From: Helen M. Taylor <helen.taylor@eversource.com>
Sent: Monday, March 05, 2018 1:19 PM
To: Walsh, Christina
Cc: Bachman, Melanie
Subject: REVISED PET 1238: 1779 Line Modifications
Attachments: AttachmentPET1238_1779_AccessPullPad.pdf

Eversource is requesting Connecticut Siting Council staff approval of the following modifications to Petition 1238:

**1779 Line
Rebuild Project
East Hartford & South Windsor
Revised Petition Map - DRAFT**

Sheet 10 of 11

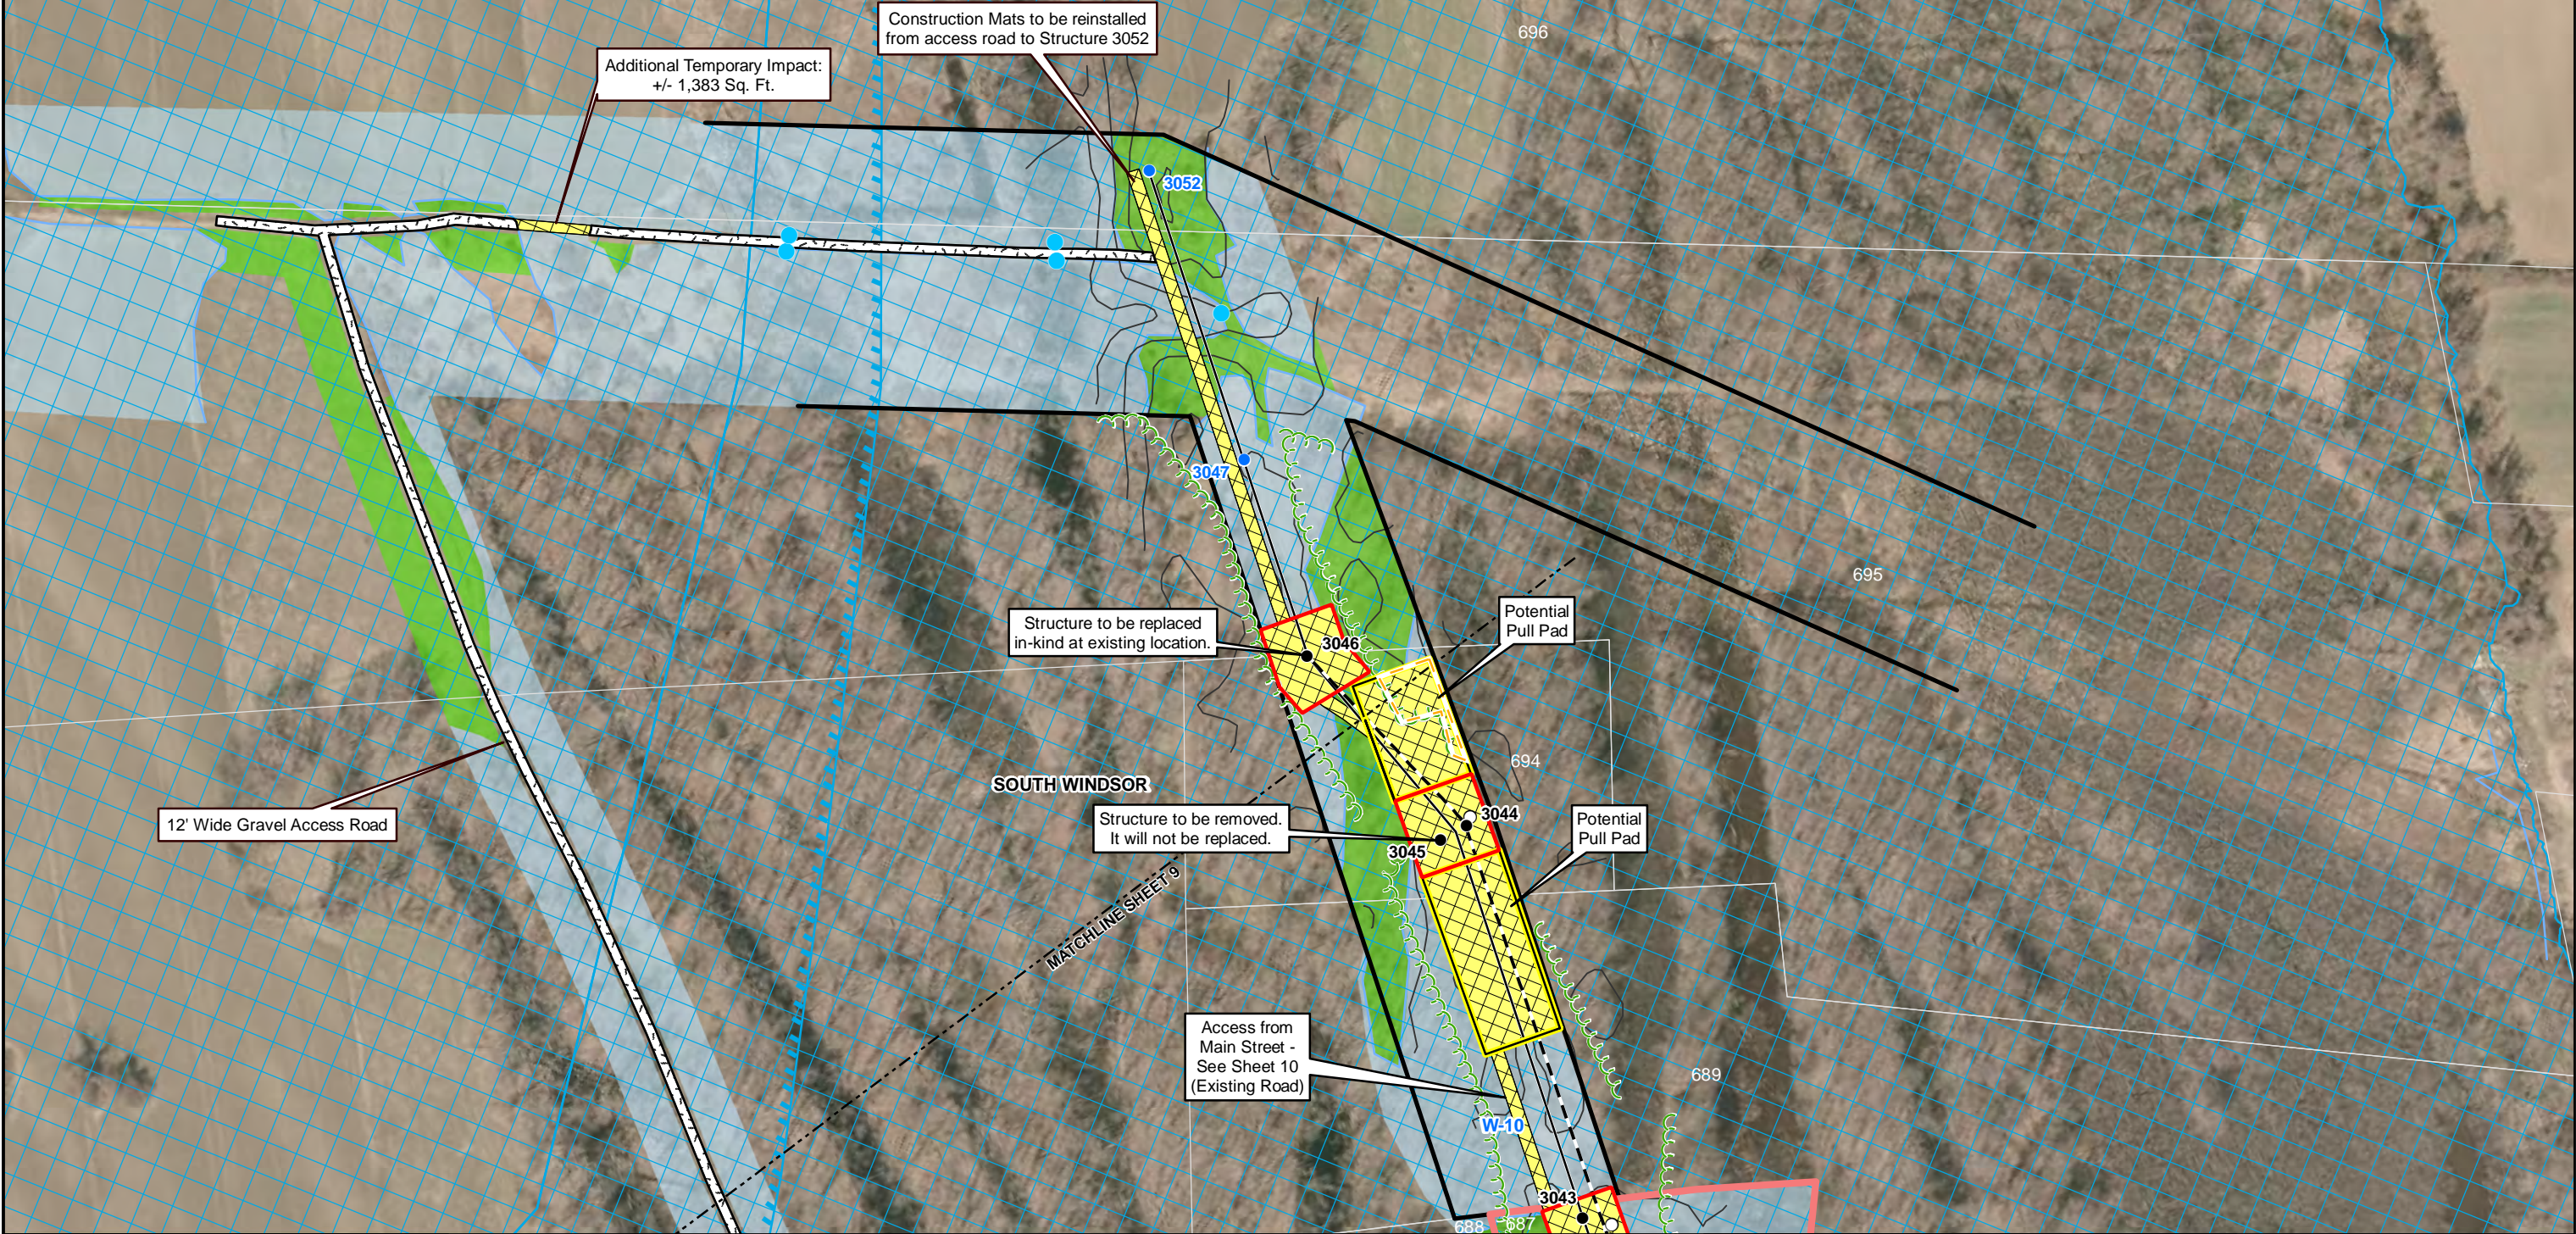
- Eversource is requesting a new access to structure 3052 from Main Street in South Windsor for splicing the OPGW. The existing mats between structures 3046 and 3052 have been removed due to flooding concerns. The new proposed access is an existing dirt and gravel road. A construction mat (16 feet x 90 feet) would be installed to protect a small wetland. There would be no permanent impacts to the wetland and vehicle use to this area will be a limited to pickup truck or a splicing van. The property owner has agreed to Eversource's use of the proposed access. See Attachment: Mapsheets 10 and 11.
